Re: DW 18-101, Pennichuck East Utility, Inc.
Supplemental Petition for Approval of Special Contract with Pillsbury for service to
Woodmont Commons in Londonderry, NH
Staff Recommendation for Approval

Petition for Approval of Special Contract for Woodmont Commons in Londonderry
Responses to Staff Data Requests – Set 4

FIG.
1

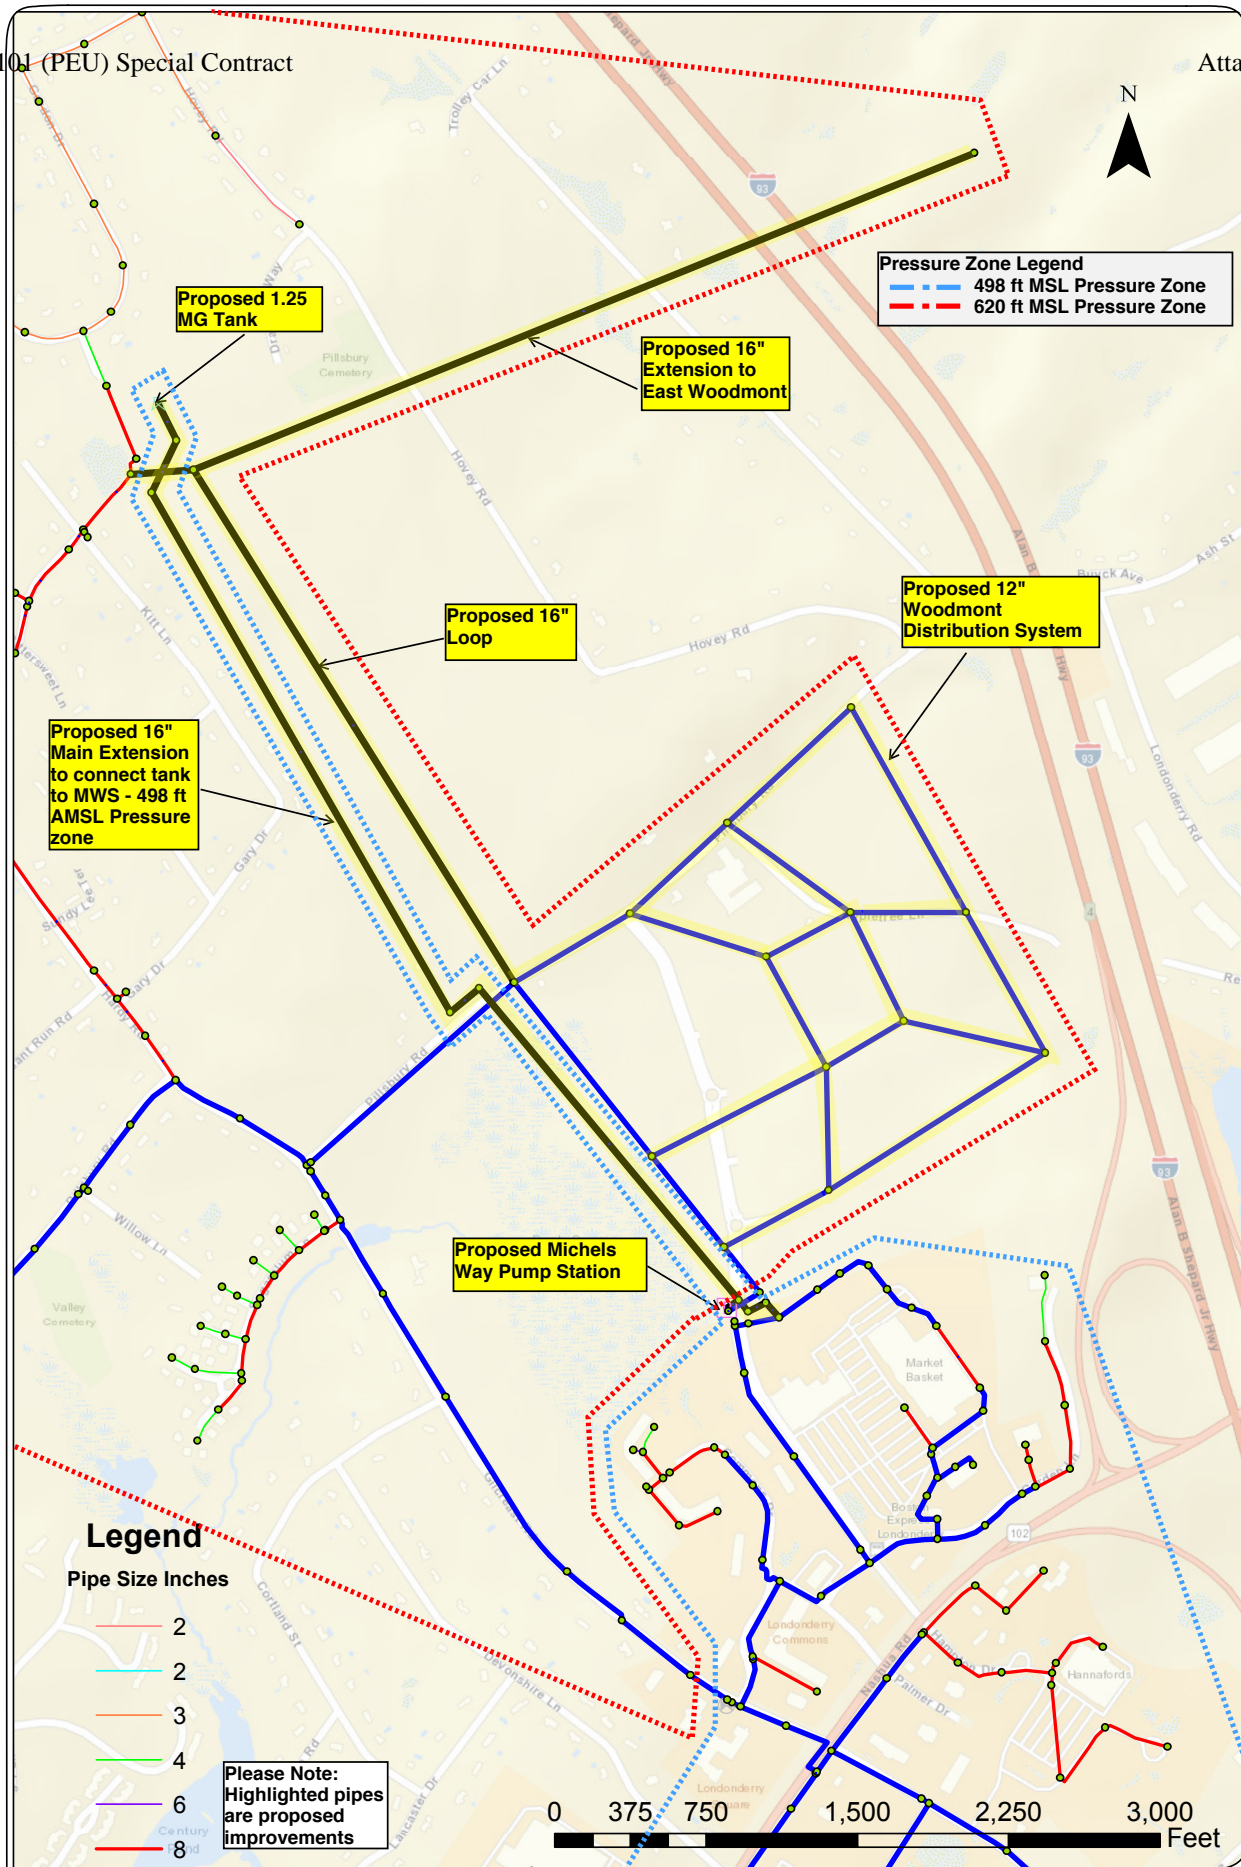
- 4,700 ft of proposed 16” ductile iron water main will extend from the existing 620 ft AMSL pressure zone off of Pillsbury Road to the north to connect with the proposed water main running to east to serve East Woodmont commons. See Figures 1 and 2.
- 1,250 ft of proposed 12” ductile iron water main will extend from the Gilcrest Road south to Orchard View Drive. This will provide additional looping near the Home Depot in the 498 ft AMSL pressure zone. See Figures 1 and 2.
- 750 ft of proposed 12” ductile iron water main will connect the two dead ends on Buttrick Road. This will provide looping in the southern end of the 498 ft AMSL pressure zone. See Figures 1 and 2.

First, Section 8.2 (System Design) requires that the System be able to meet both the maximum domestic demand and fire flows simultaneously. In order to evaluate this standard, UE simulated fire flows while constant MDF demands were applied. Fire flows were simulated at the same locations as the flow test locations defined in the prior technical memorandum titled "Londonderry Distribution System Analysis." See Figure 1

Second, Section 8.2.1 (Pressure) requires that a minimum pressure of 20 psi be maintained throughout the entire distribution system under all conditions of flow. UE set all nodes within the pressure zone of investigation to a minimum residual pressure of 20 psi to ensure compliance with this standard. This constraint controlled the available fire flow. The limiting node locations are identified in Appendix B and shown on Figure 1.
